PDB issues and Production Plan

**M. Citterio, M. Lazzaroni, S. Latorre,
F. Tartarelli**

AUW (April 08, 2019)

Proposed solution

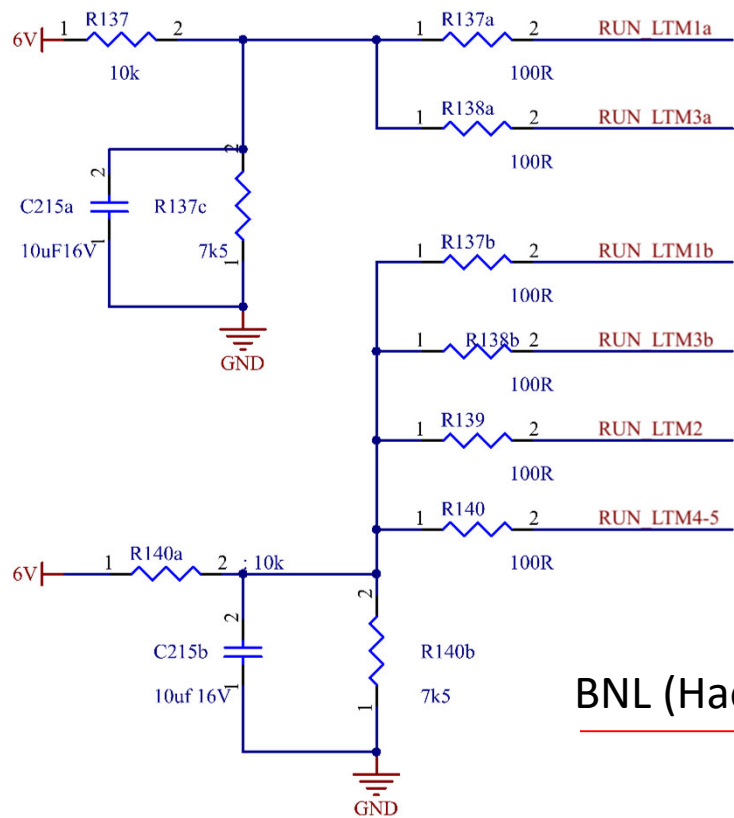
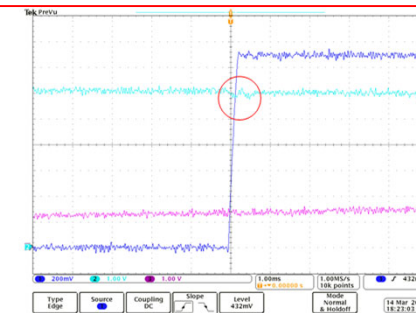
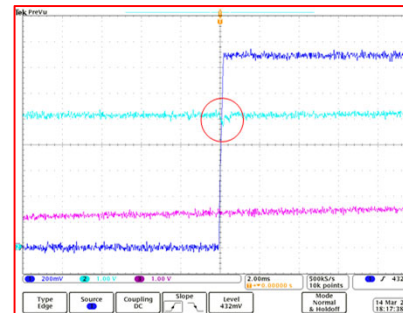
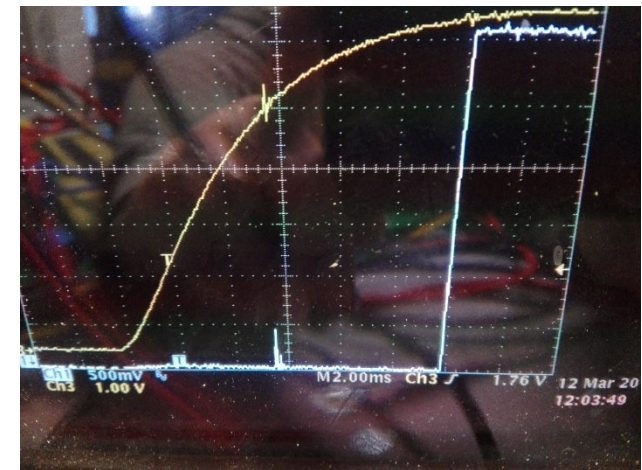
- One or more short reset events of the LTM device can be observed (in particular with VICOR LVPS).
- This is mainly due to the behavior of the output voltage of the LVPS (which is the input voltage of the LTM).
- This is well clear when the LTM starts (see the red circles on the figures).
- The output voltage of the power supply tends to decrease just enough so that in some situations it falls below the minimum operating value of the LTM devices (4.5 V).

delay the switching ON of the LTM device when the LVPS device has reached a value of its output voltage (>> 4.5 V) such as to prevent the switching OFF of the LTM device

- This soft start circuit modification is strictly necessary only for the 2 output voltages from LTM 1 and 3 but, in order to have the best flexibility, the new circuit has been implemented for all the LTM devices.

- Solution successfully tested on PDB v3 both in Milano and at BNL
- Change implemented in PDB v4

- Vicor LVPS
- 10K/7.5K/10uF
- No start up trip
- Drop off of 6V input is ~400mV

- Wiener LVPS
- 10K/7.5K/10uF
- No start up trip
- Drop off of 6V input is ~200mV
